SUBJECT: ISSUANCE OF AMENDMENT NO. 119 TO FACILITY OPERATING LICENSE NO. NPF-12 REGARDING STEAM GENERATOR REPLACEMENT - VIRGIL C. SUMMER NUCLEAR STATION, UNIT NO. 1 (TAC NO. M88172)

AMENDMENT TO FACILITY OPERATING LICENSE

Amendment No. 119
License No. NPF-12

ATTACHMENT TO LICENSE AMENDMENT NO. 119
TO FACILITY OPERATING LICENSE NO. NPF-12
DOCKET NO. 50-395

FIGURE 3.1-3
REQUIRED SHUTDOWN MARGIN
(MODES 3, 4, AND 5)

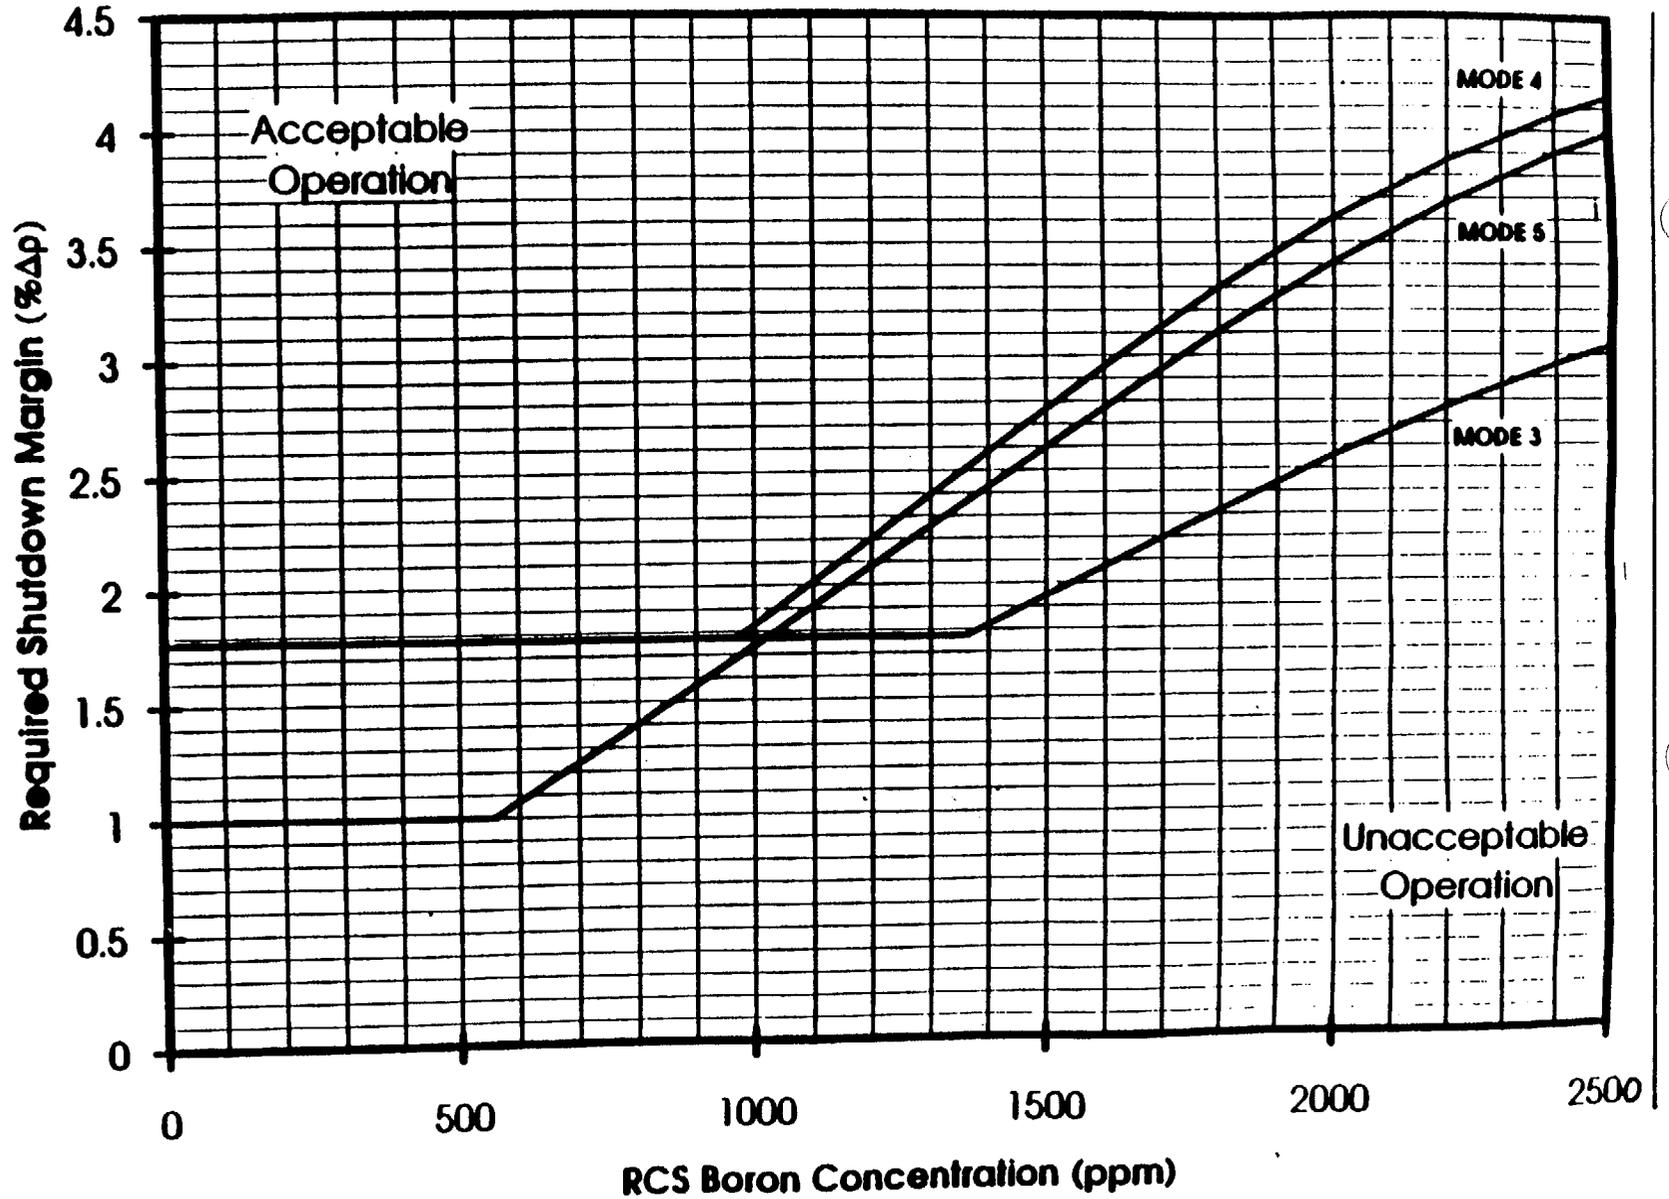
TS Figure 3.1-3 defines the shutdown margin requirement as a function of average RCS boron concentration during Modes 3, 4, and 5 of reactor operation. In these modes, the most limiting event is a boron dilution event. The licensee has performed a new analysis for a boron dilution event using the revised shutdown margin requirement. The results of the analysis demonstrate that the time available between the time an alarm announces an unplanned moderator dilution and the time of loss of shutdown margin is sufficient for the operator to take action to terminate the event. The staff considers the proposed change of TS Figure 3.1-3 acceptable.
